**Proposed**Modified: TP-201.1A

Emission Factor For  
Phase I Systems at Dispensing Facilities

Adopted: April 12, 1996  
Amended: March 17, 1999  
Amended: \_\_\_\_\_

Proposed 15-day changes are shown with underline for additions and ~~strikeout for deletions~~.

**Figure 1  
Test Locations**

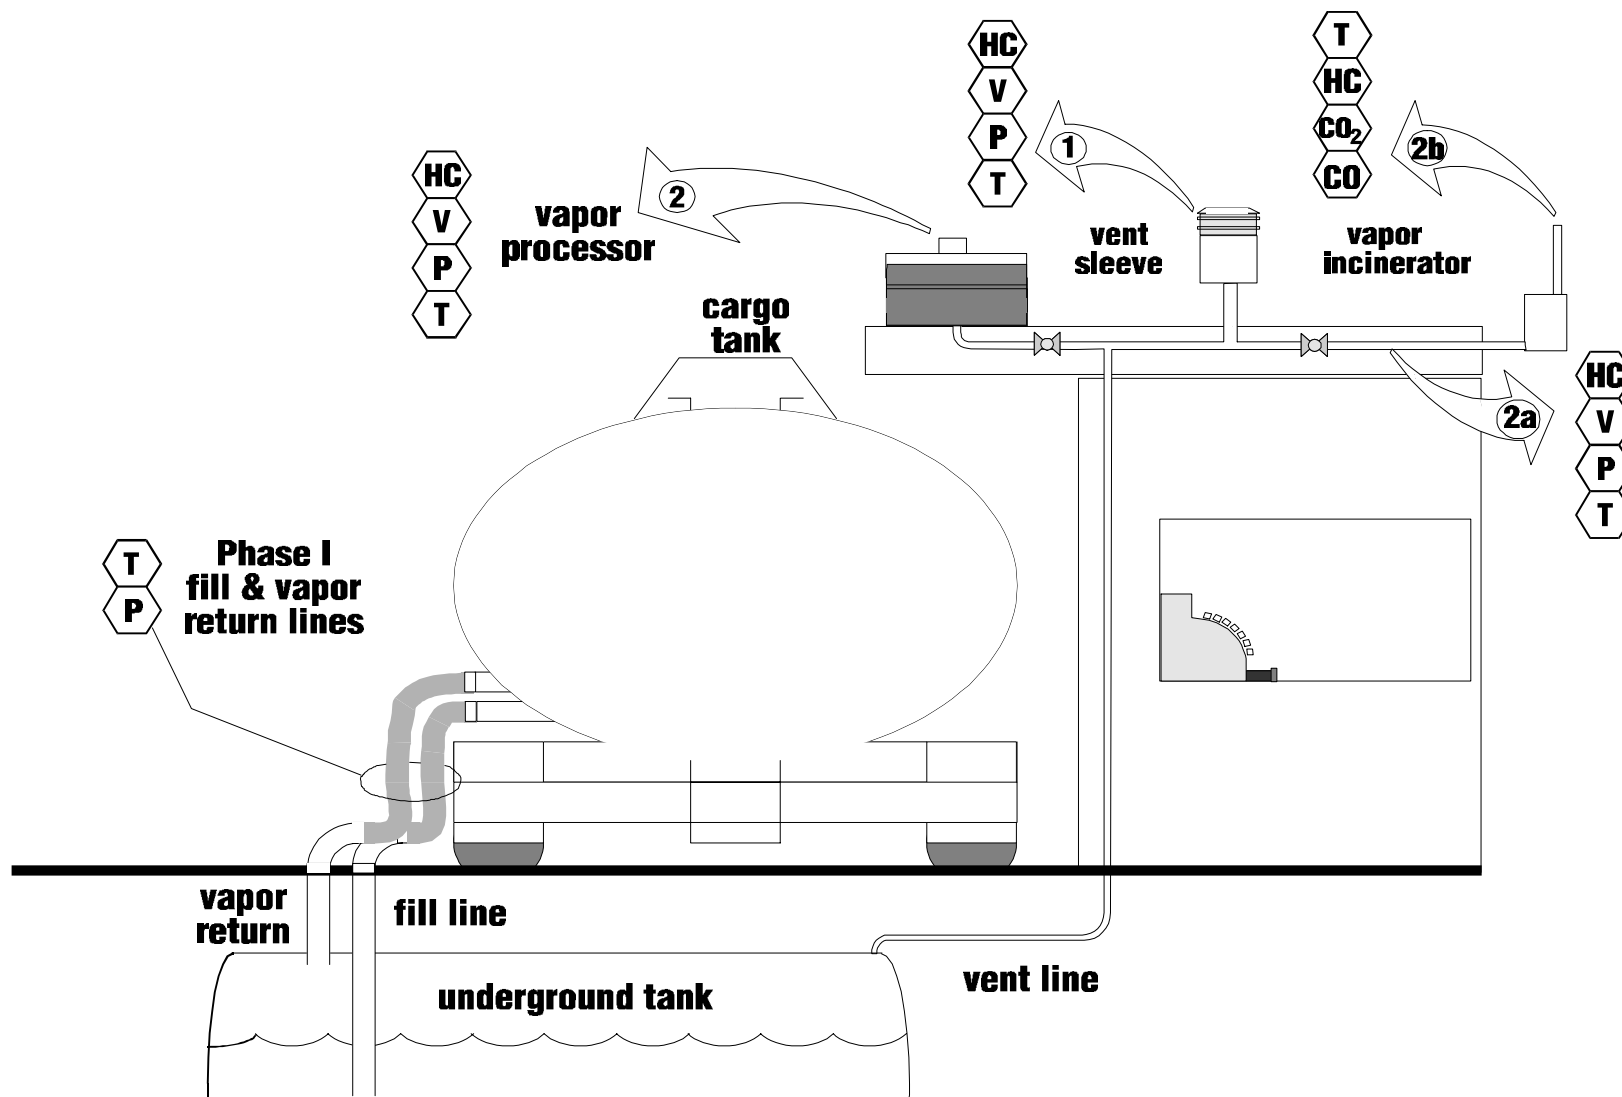
During TP-201.1A testing continuous measurements shall be recorded for the following system parameters shown in hexagon outlines in Figure 1:

HC	=	Hydrocarbon Concentration at inlet and exhaust test points
CO	=	Carbon Monoxide Concentration at exhaust test point
CO <sub>2</sub>	=	Carbon Dioxide Concentration at exhaust test point
V	=	Volume at inlet test point
P	=	Pressure in meter at inlet test point
T	=	Temperature in meter at inlet test point
